VALUE ENGINEERING WORKSHOP

SR 316 FROM I-85 TO SR 20 FOR HOV LANES Gwinnett County, GA

21 April 2005

VALUE ENGINEERING TEAM STUDY

ORIGINAL DESIGN SKETCH/DETAIL

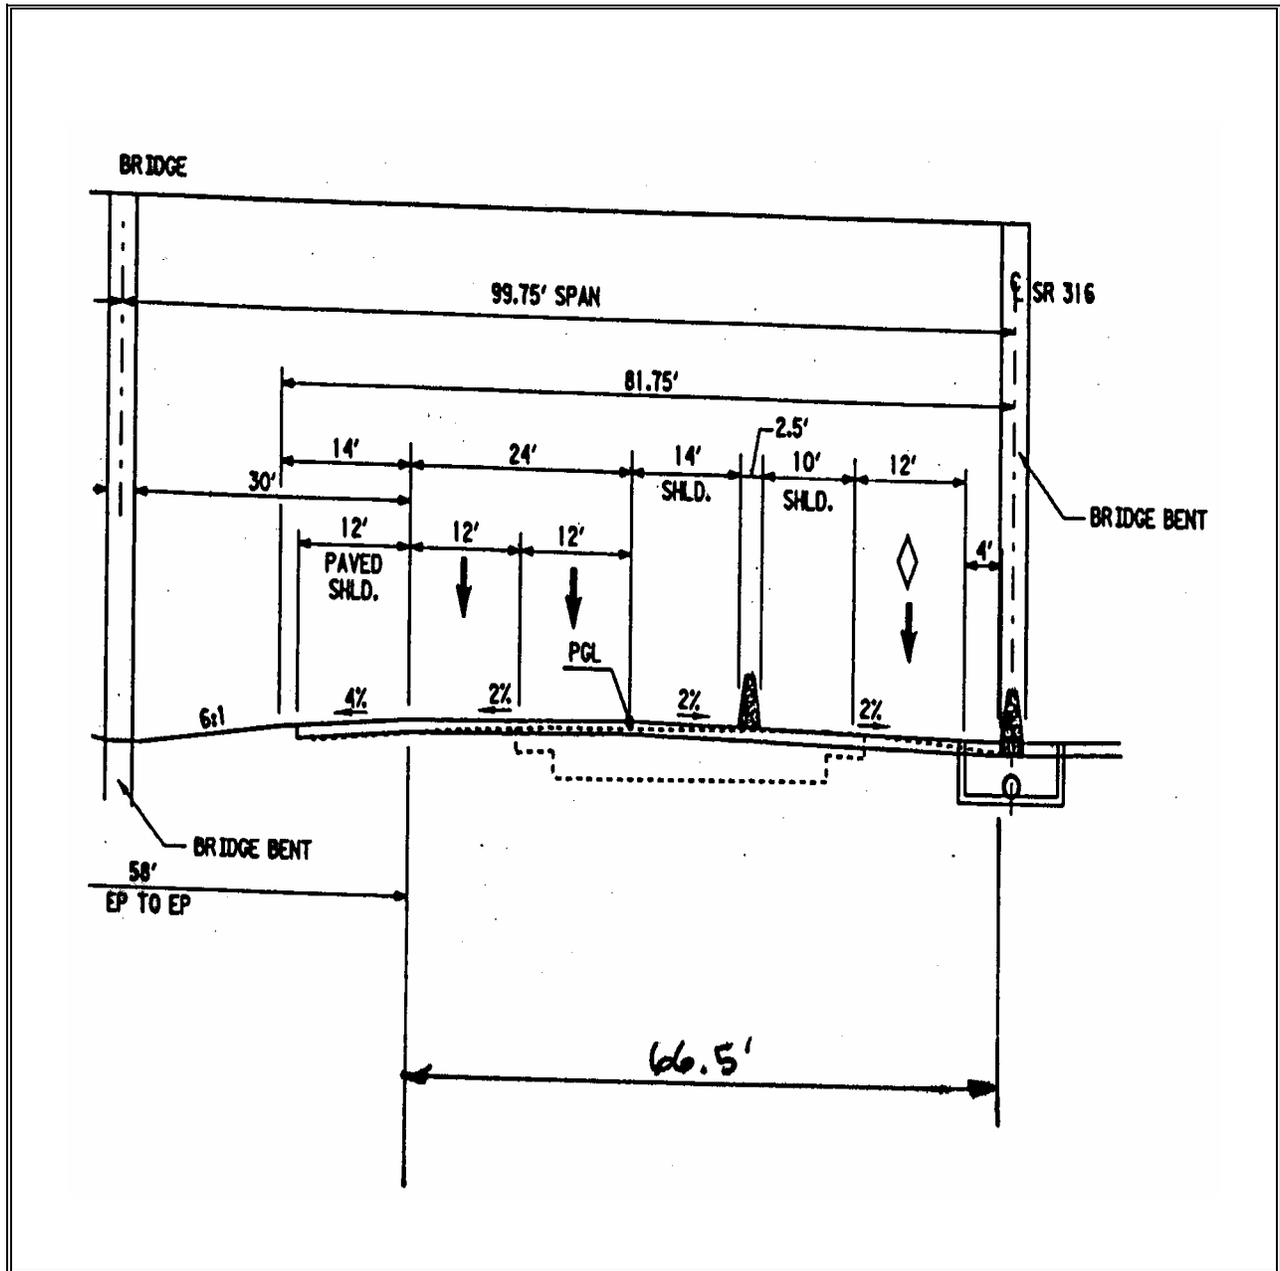
PROPOSAL DESCRIPTION: CONSTRUCT HOV WITHOUT BARRIER AND REDUCE PAVEMENT WIDTH.

ORIGINAL DESIGN: The proposed project would construct barrier separated HOV lanes and allow for HOV only access points throughout the project corridor. The Office of Materials & Research reported that “reconstruction of SR316 should consist of removal and replacement of the Asphalt Concrete and PCC pavement layers and replacement with PCC pavement.”

PROPOSED CHANGE: The proposed change would construct buffer separated HOV and allow for HOV access at designated points throughout the project corridor. The same pavement section as in the original design is assumed. This proposed change is for roadway only. See proposal SB-01 for bridges.

ORIGINAL DESIGN SKETCH/DETAIL

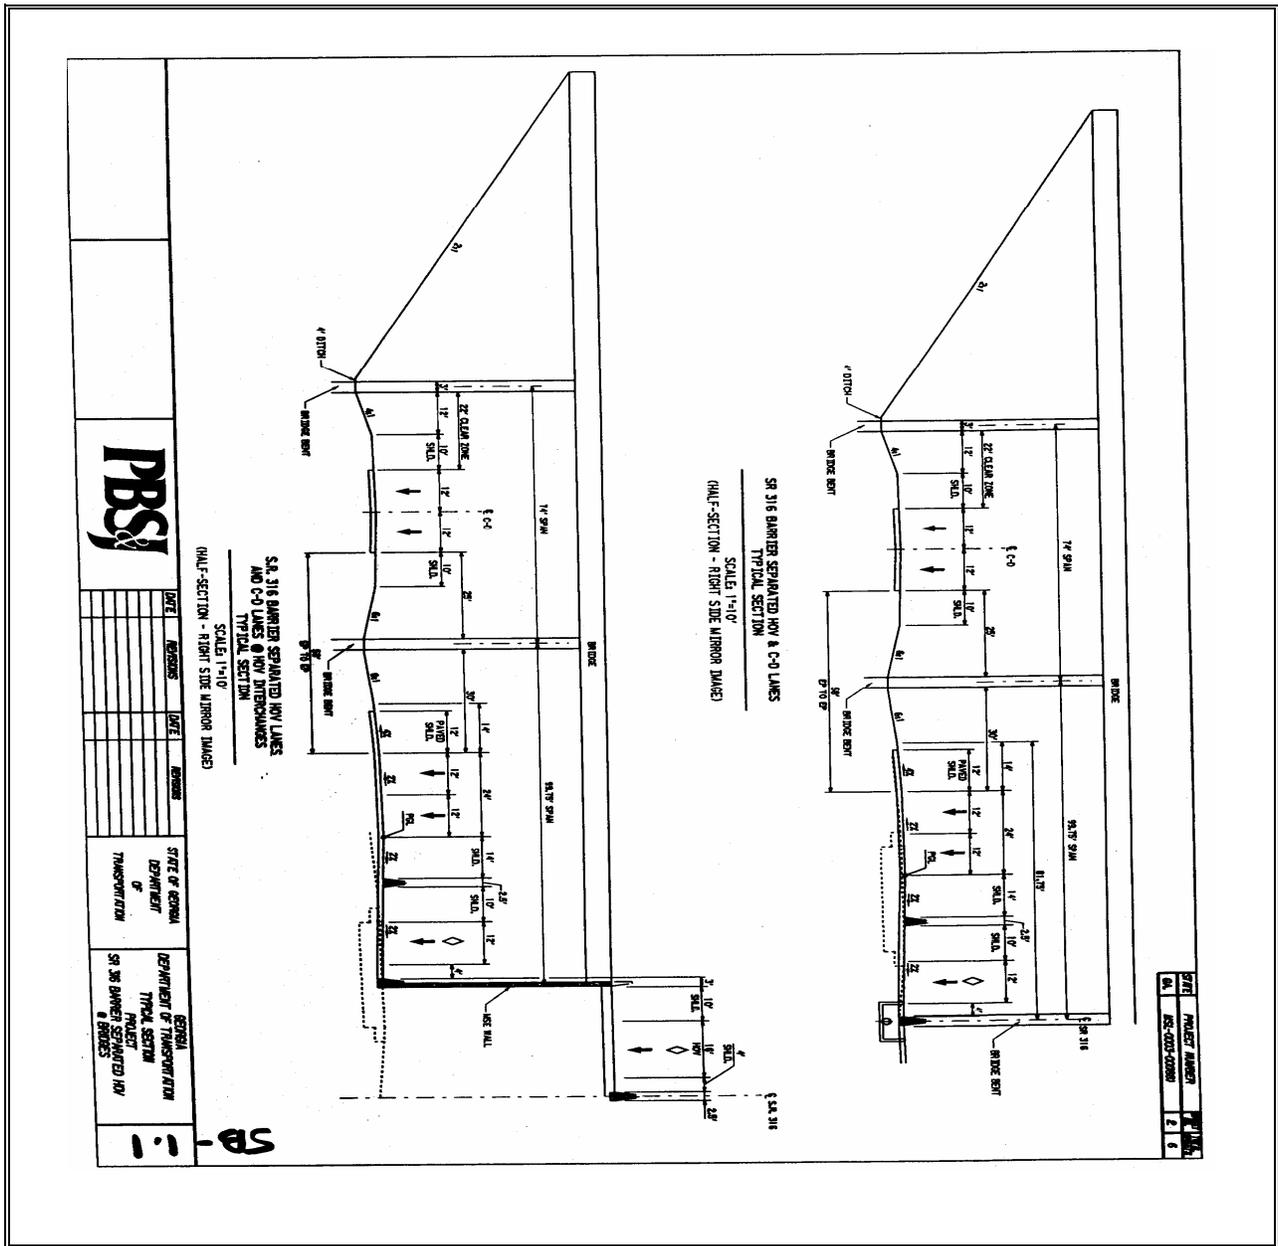
PROPOSED CHANGE: The proposed design advocates the elimination of the barrier separated HOVs and sanctions the striped HOVs since it drastically reduces the typical section of the project and allows the utilization of the existing bridges as they are with no replacement or rehab. The sufficiency ratings of these bridges, on average, are 80-90 which extend the life span of these bridges by at least 30 years. The modified section will be comprised of an outside 10'0" shoulder plus 2 lanes @ 12'-0" plus 1 HOV lane @ 16'-0" plus 4'-0" inside shoulder resulting in a section that is less than 60'-0" center-center of existing bents. (Requires approval to change criteria)

ORIGINAL DESIGN SKETCH/DETAIL

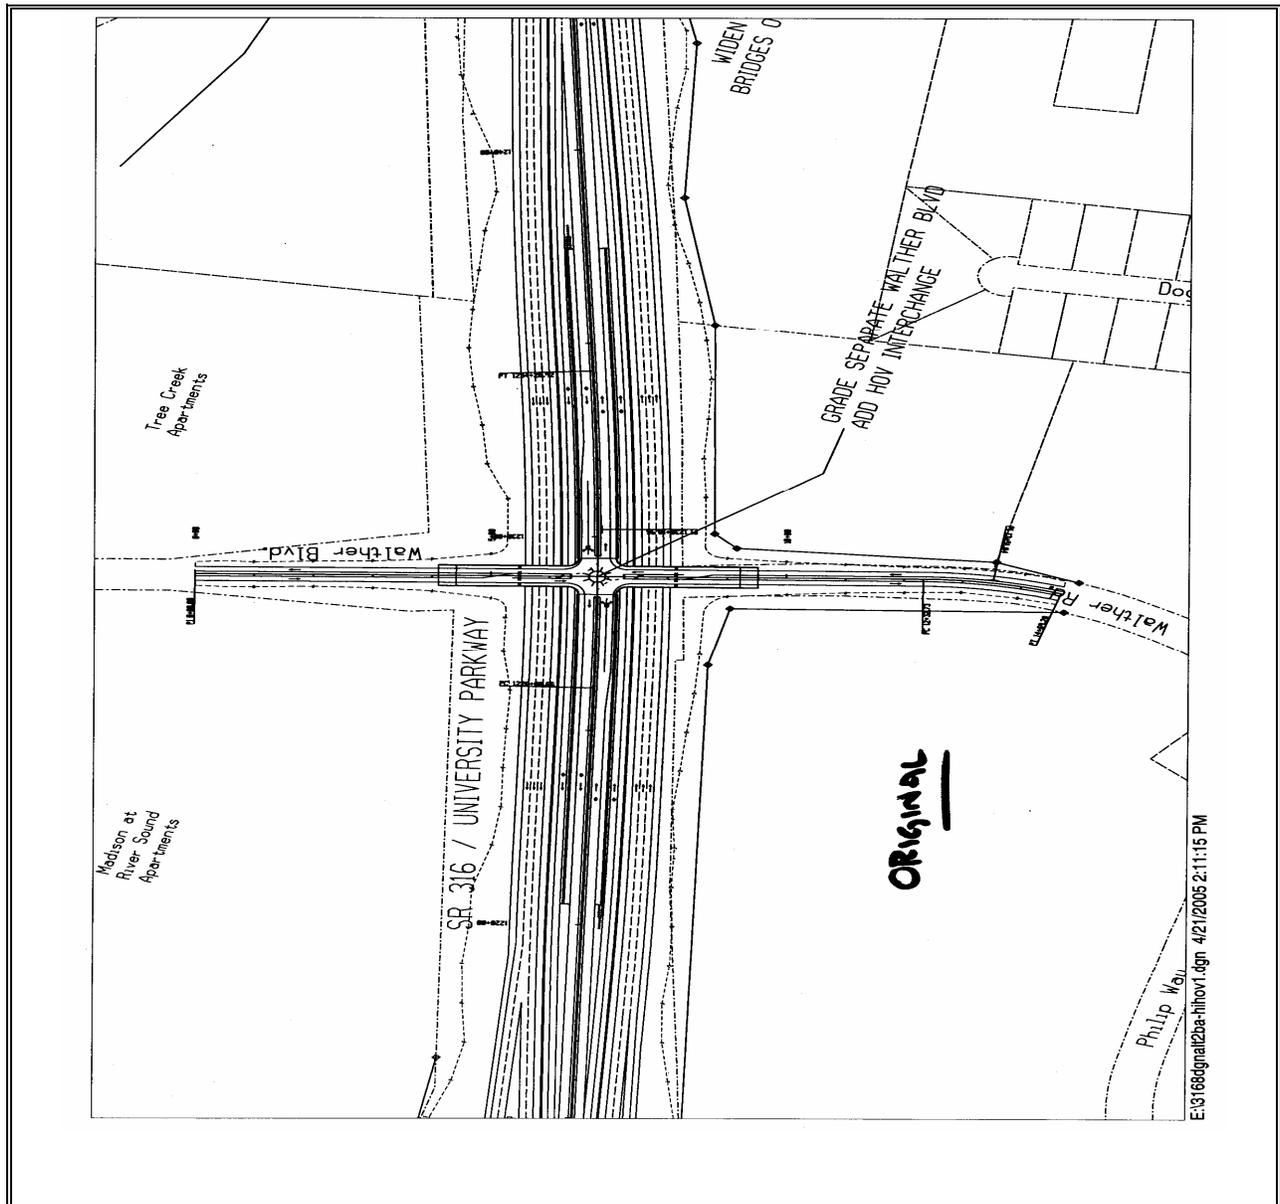
PROPOSED CHANGE: The proposed design proposes the use of 53’ arch culverts that run along Walther Road and end at a depressed HOV interchange under SR 316. The interchange will be approximately 50 wide in perimeters.
